**GEOTECHNICAL DESIGN & MATERIALS REPORT  
MARE ISLAND/ROUTE 37 PROJECT  
04-SOL-37/KP 11.4-11.9  
SOLANO COUNTY, CA  
EA 284700, CU 04277**

**Caltrans Comments & Responses**

Sub: Response to Caltrans Office of Geotechnical Design Comments

This letter is a response to the comments by Caltrans on the above reference report. The comments and respective responses are listed below for convenience.

**SITE PLAN**

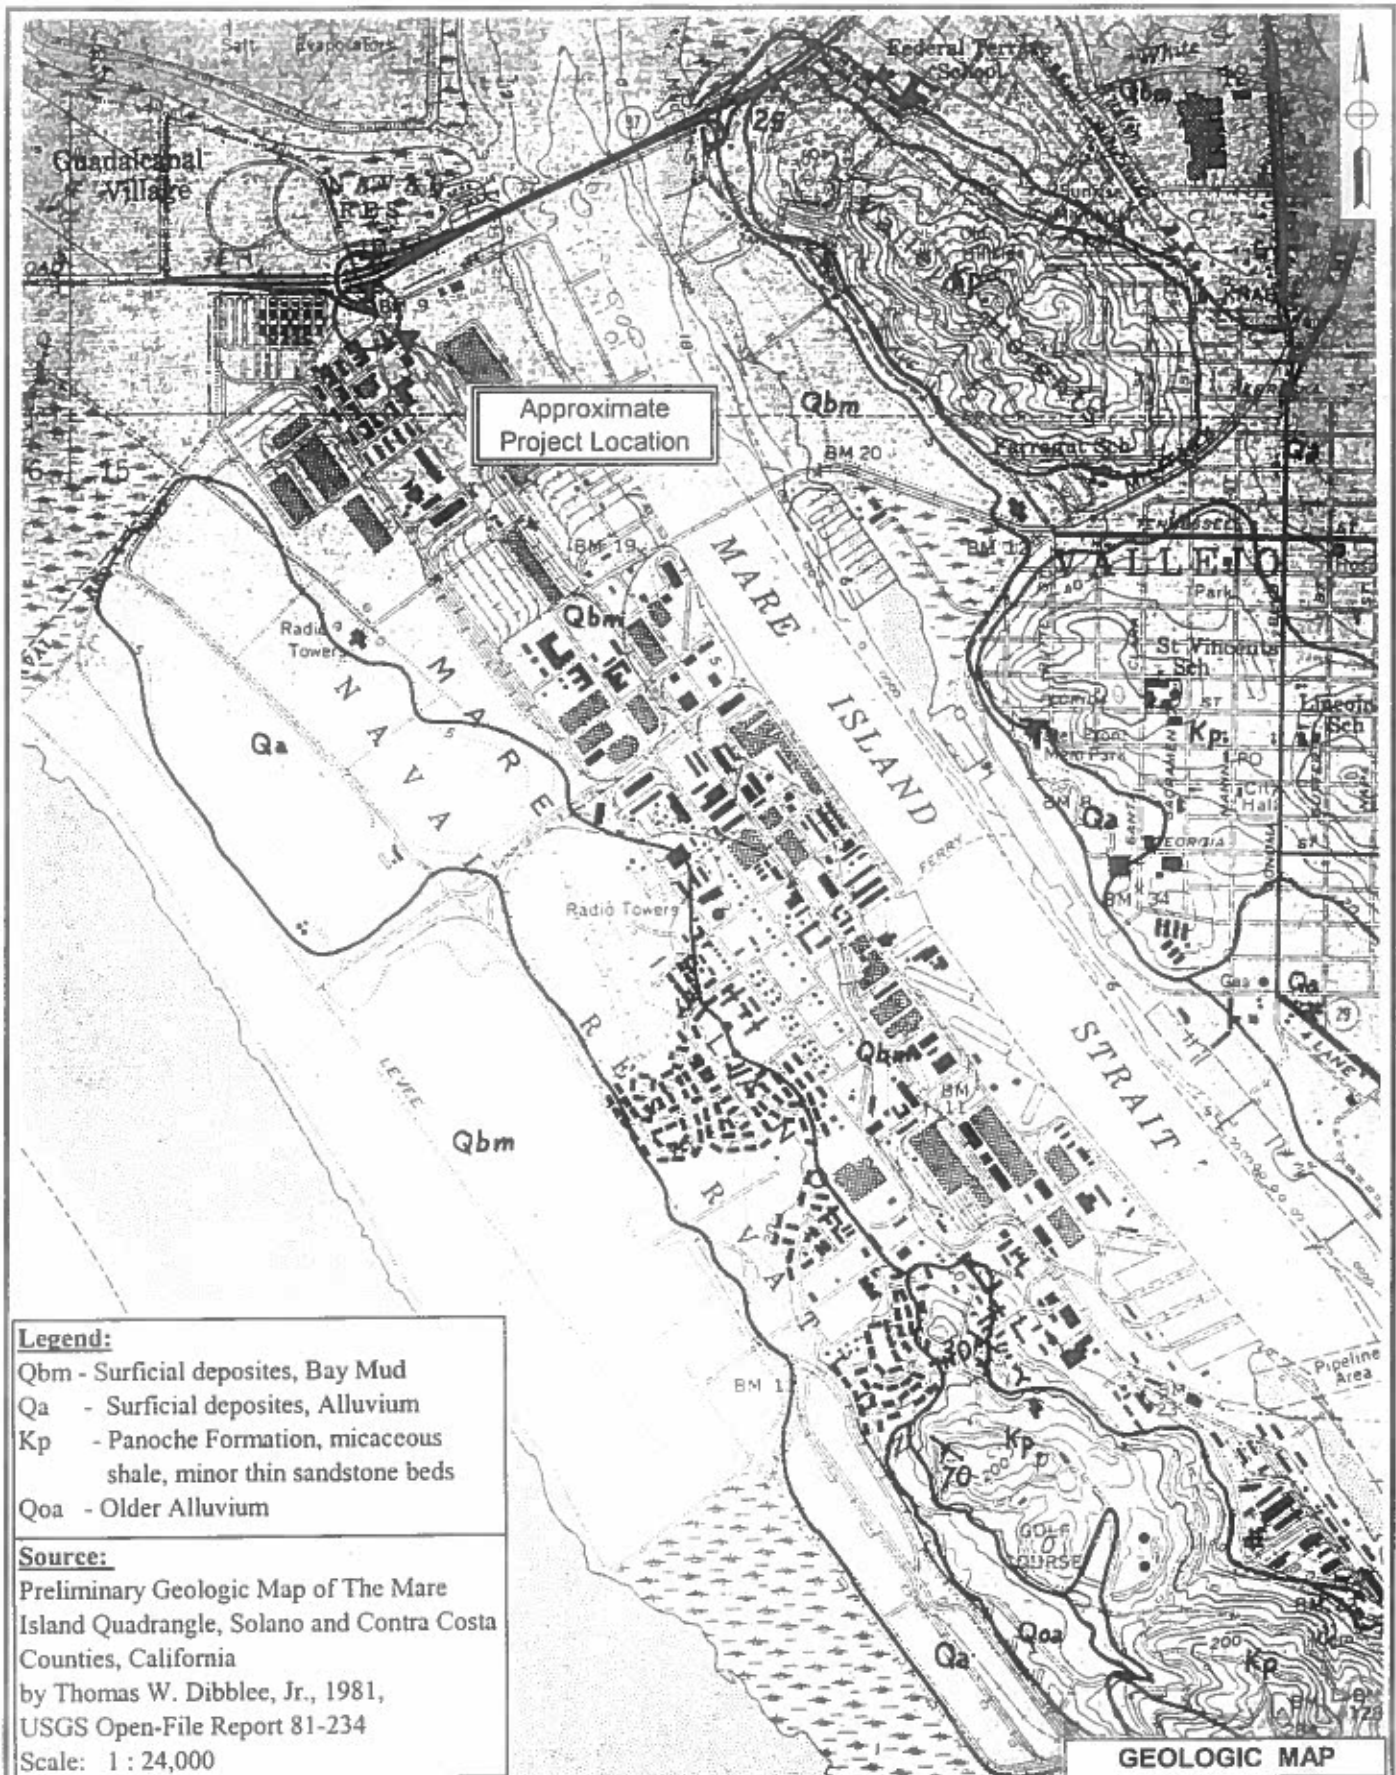
15. Site Plan, Plate 2. Add boring locations BM-1 and BM-2 to the site Plan.

Response: Will comply.

**FAULT MAP**

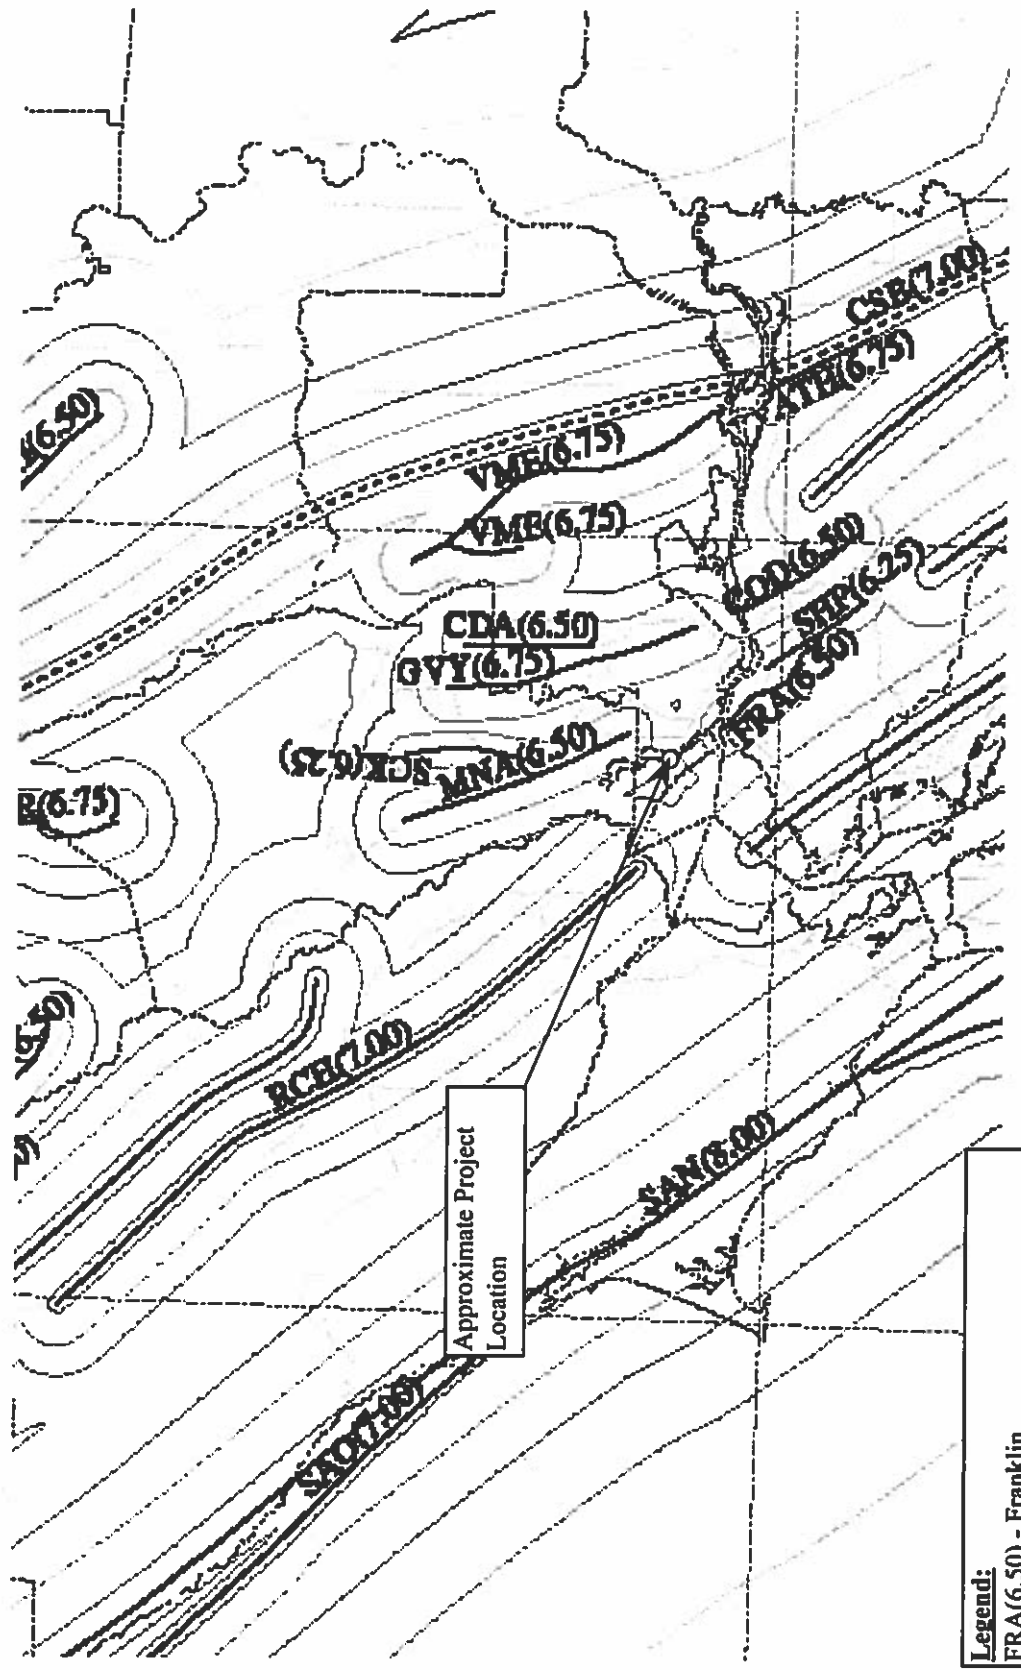
17. Fault Map, Plate 4. The map is not legible. Provide a legible Fault Map.

Response: Will comply.
